<SUPPLEMENT-II>

REAR AXLE & REAR SUSPENSION

SECTION **RA**

MODIFICATION NOTICE:

SRA593CB

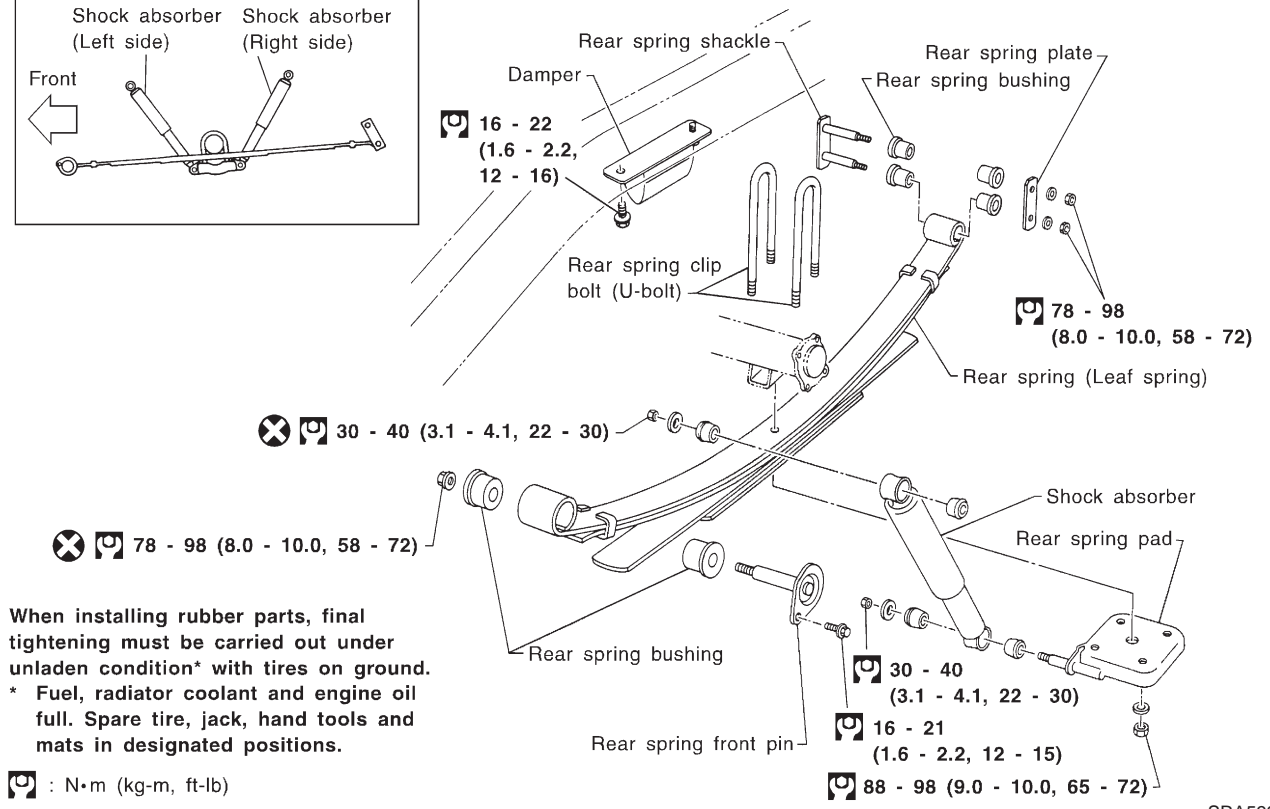
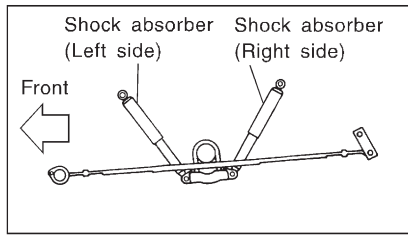
Tightening torque of rear spring front pin mounting bolts has been changed.

When installing rubber parts, final tightening must be carried out under unladen condition* with tires on ground.
 * Fuel, radiator coolant and engine oil full. Spare tire, jack, hand tools and mats in designated positions.
